Access Compliance Report

Public Rights-of-Way

Intersection ID: 10067	Main Street: ETHEL_GUEST_LN	Cross Street: OAKLAWN_AV	Location: NE
ADA ID: 79105C340004	Ramp Type: PerpDiag	Initial Pass/Fail: Fail	Overall Compliance: No
Severity Score: 13.75			
Codes/Mitigation Info/Possible Solution		Field Measurements/Component Compliance

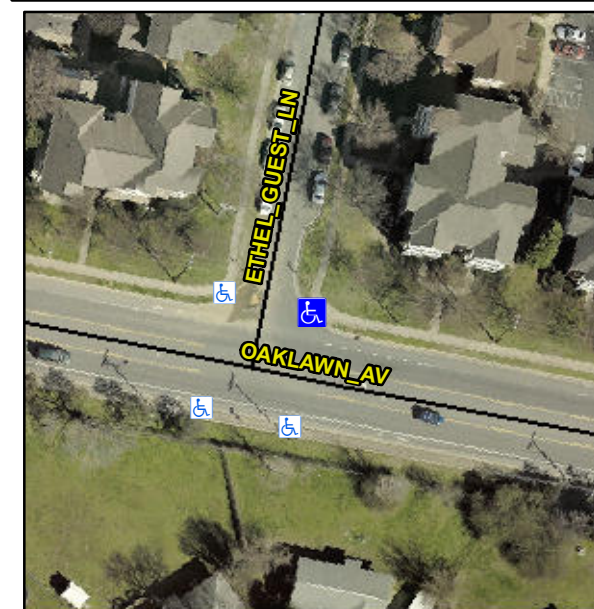
Not Found, R304.2.2, R304.5.3

Compliance	Description	Data	Compliance	Description	Data
N/A	Ramp Length (in)	48.0	No	Ramp Slope (%)	10.9
Yes	Ramp Width (in)	53.0	No	Ramp XSlope (%)	4.2
N/A	Flare Type LT	N/A	N/A	Flare Type RT	N/A
N/A	Flare Slope LT (%)	N/A	N/A	Flare Slope RT (%)	N/A
N/A	Flare Traversable LT?	N/A	N/A	Flare Traversable RT?	N/A
N/A	Landing Length (in)	N/A	N/A	DWS Provided?	N/A
N/A	Landing Width (in)	N/A	N/A	DWS Contrast?	N/A
N/A	Landing Slope (%)	N/A	N/A	DWS Length (in)	N/A
N/A	Landing X Slope (%)	N/A	N/A	DWS Full Width?	N/A
N/A	Landing Curb? (Y/N)	N/A	N/A	DWS Offset (in)	N/A
N/A	Shared Landing?	N/A			
N/A	Gutter Ponding?	N/A	N/A	Gutter Slope (%)	N/A
N/A	Gutter Lip Ht (in)	N/A	N/A	Gutter X Slope (%)	N/A
N/A	Painted X Walk1?	No	N/A	Painted X Walk2?	No
	X Walk 1 Direction	To NW		X Walk 2 Direction	To SW
N/A	X Walk 1 Width (in)	N/A	N/A	X Walk 2 Width (in)	N/A
	X Walk 1 Slope (%)	3.4		X Walk 2 Slope (%)	2.7
	X Walk 1 X Slope (%)	3.9		X Walk 2 X Slope (%)	2.1

Remove & Replace Curb Ramp With Two New Directional Ramps or Equivalent.
